GRADING AND DRAINAGE PLAN  
FOR  
LOT 17-A, MERIDIAN BUSINESS PARK

DRAINAGE PLAN

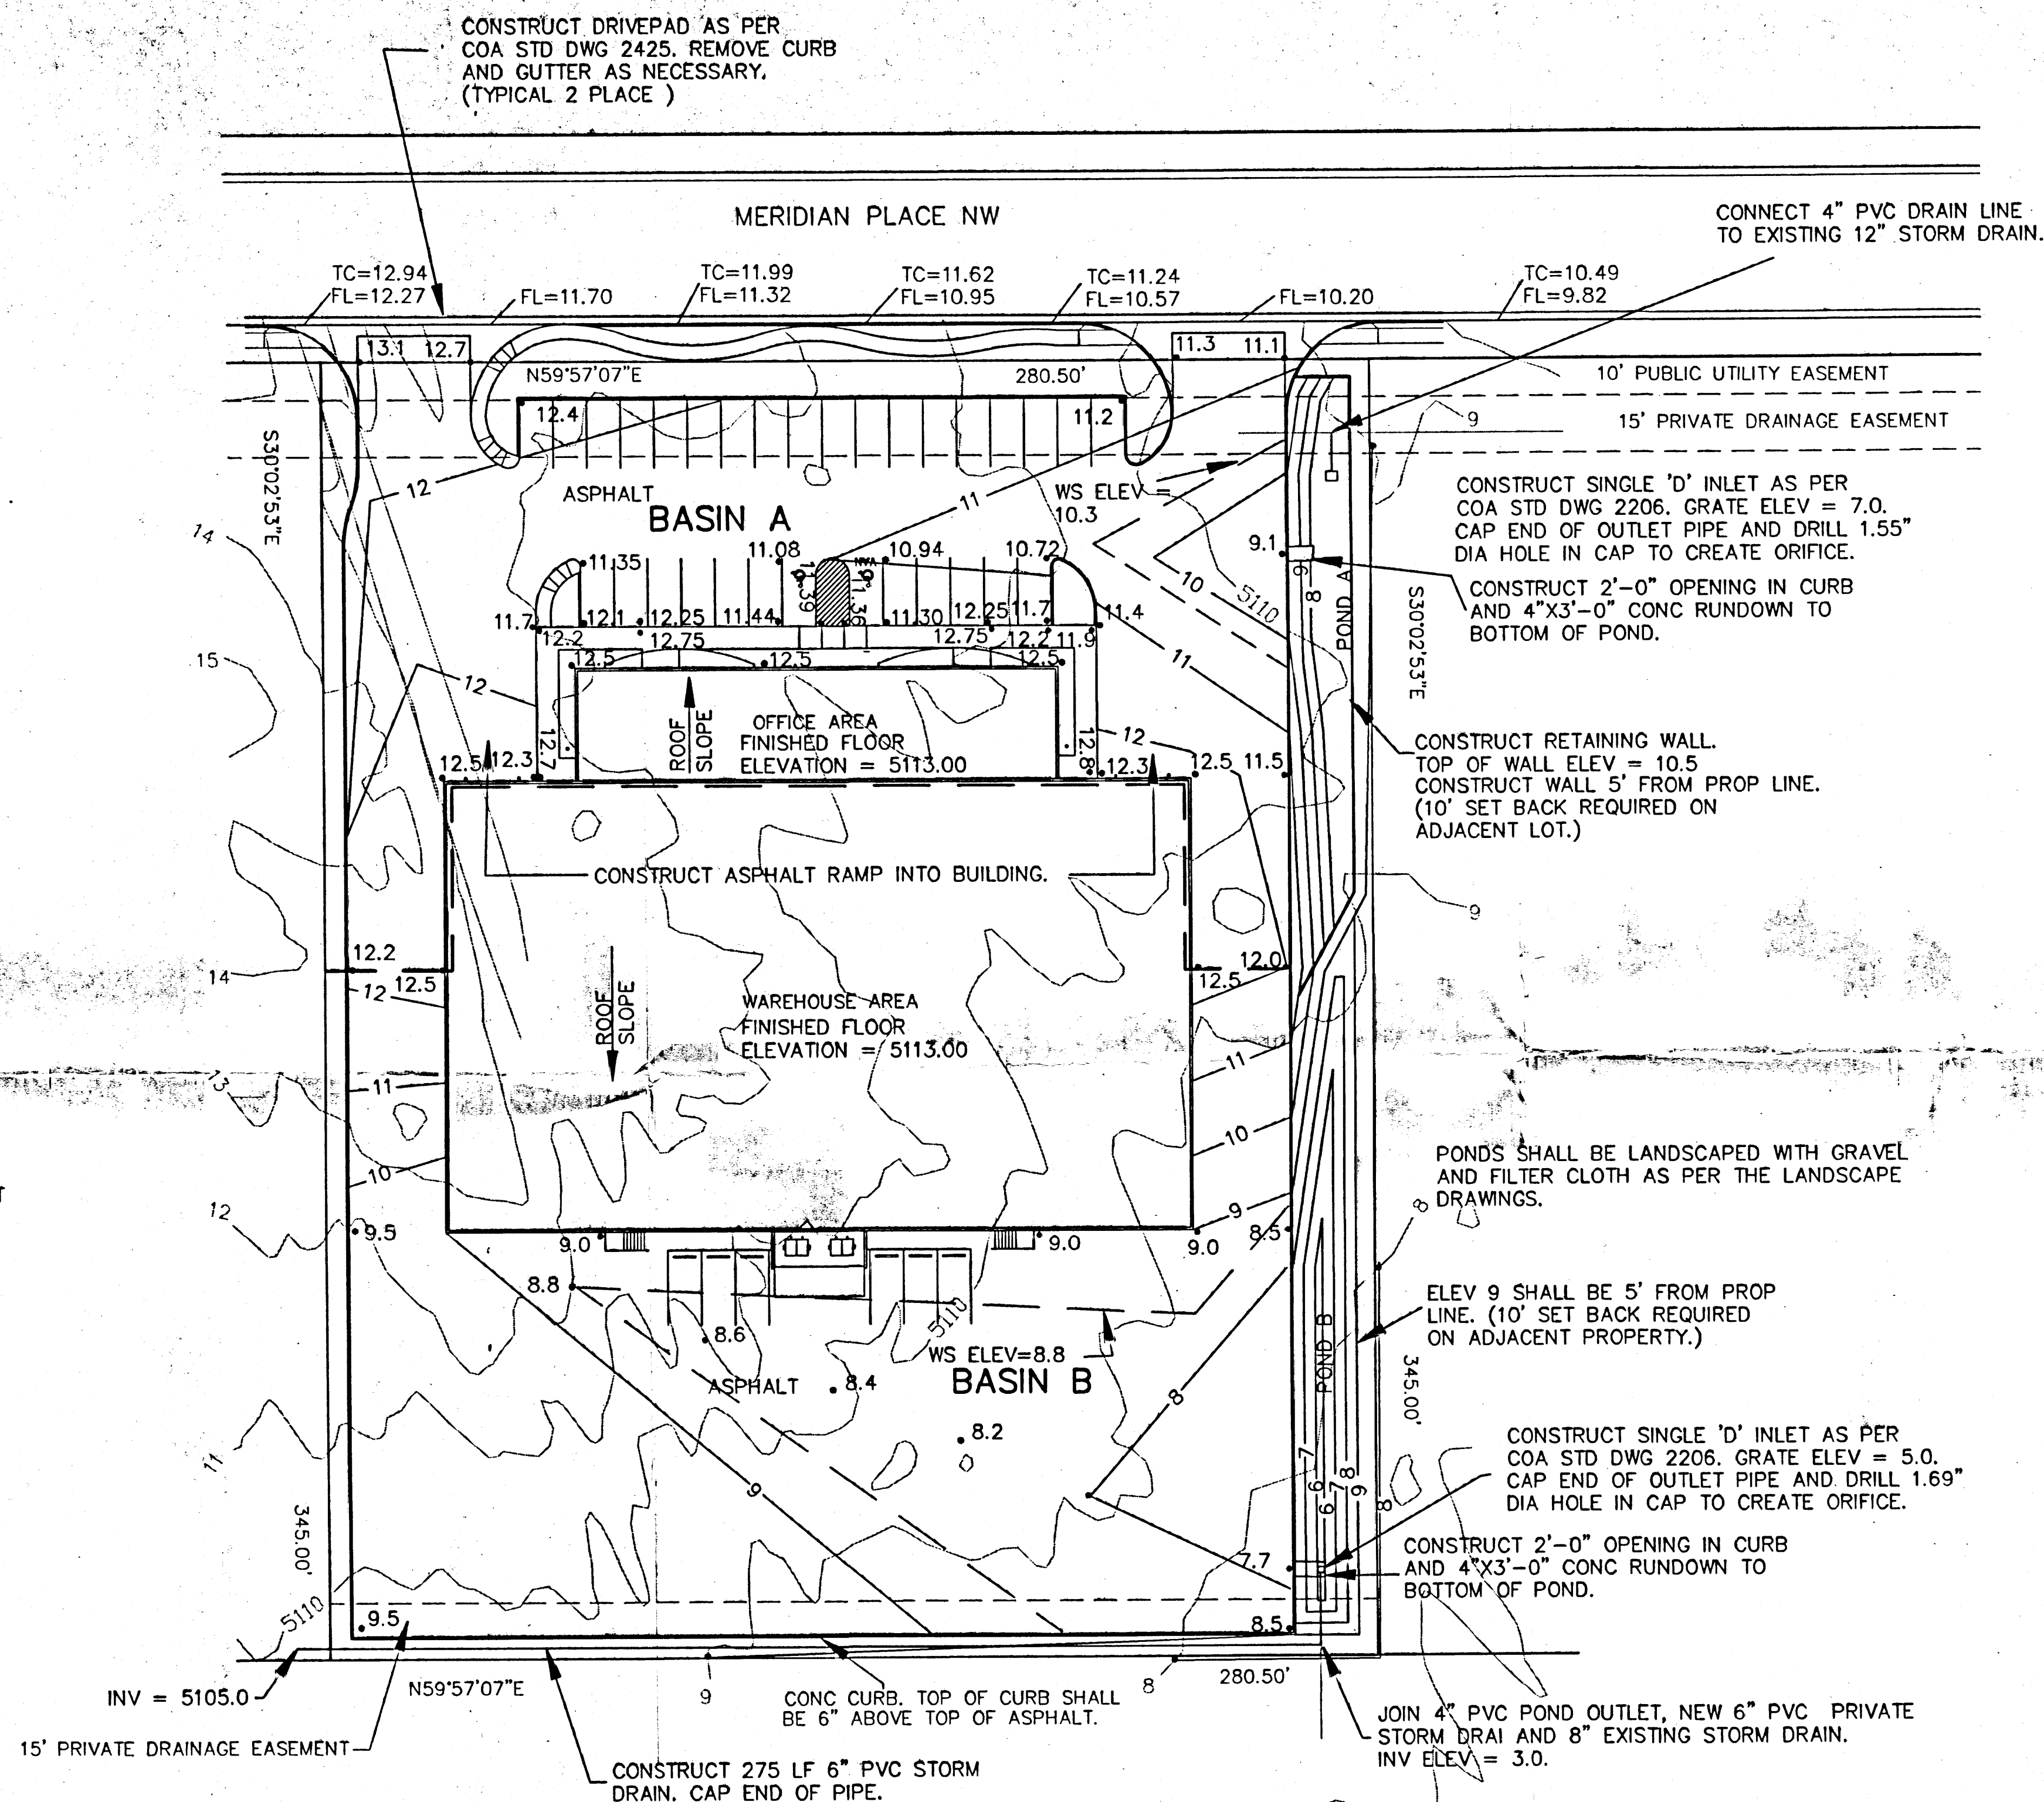
1. Address the clearance of the ponds to the proposed 10' public utility easement.
2. What type of erosion control is required? (DPM check sheet will help)
3. Extension of the pipe to the edge of the west property line.
4. Indicate how and where the proposed 10' public utility easement will take place.
5. Detail of the proposed orifice.
6. How you verify surface elevation within the ponds.
7. Indicate the proposed curb elevations within the ponds.
8. Indicate the proposed curb elevations.
9. Is the complete site 5m to be paved?
